**PROJECT :** REPAIR/RENOVATION AND MAINTENANCE OF ITDI BUILDINGS AND FACILITIES

**SUBJECT :** BID BULLETIN NO. 1

**Date :** November 3, 2014

⊙ ROOF PLAN ⊙

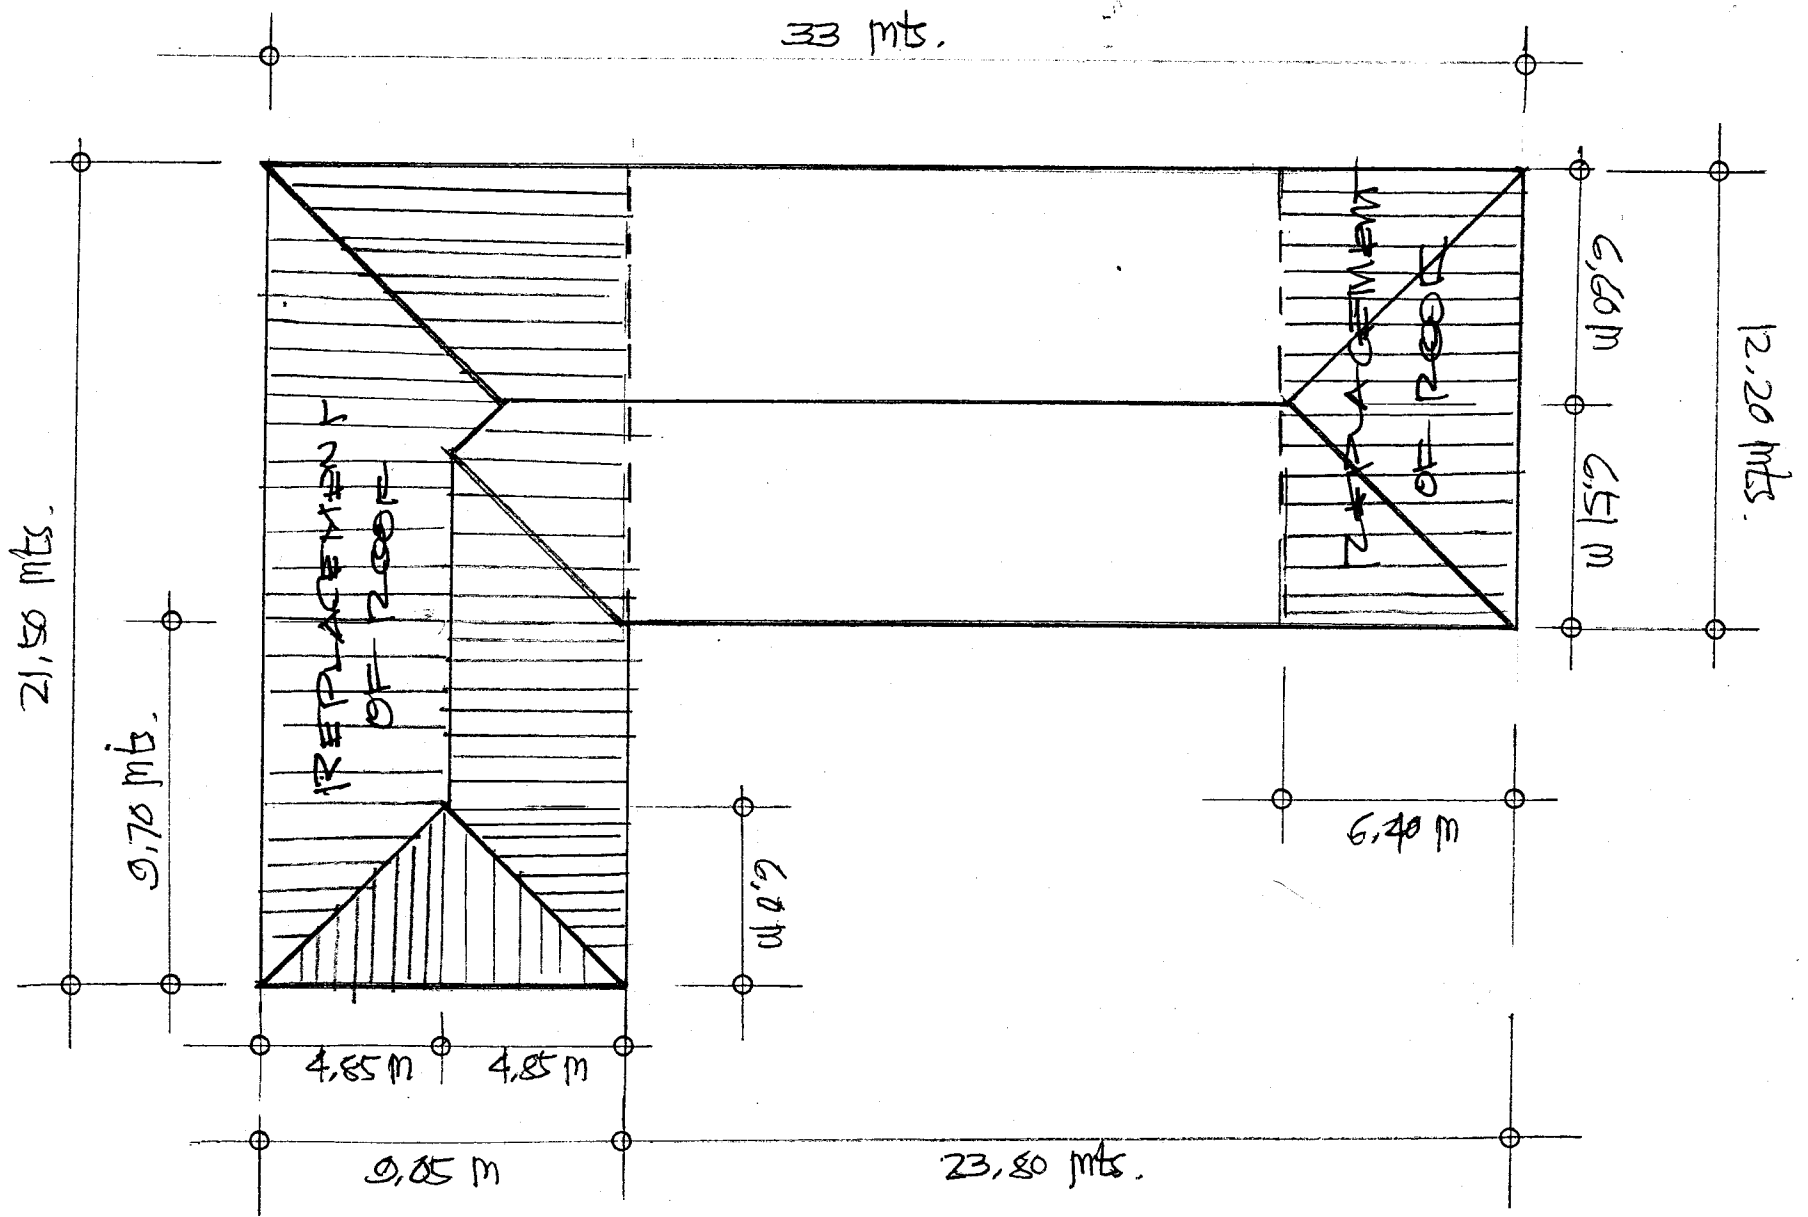
- c. Replacement of Tri-wave roof with an area of 300 sq.m (Roof Plan attached)
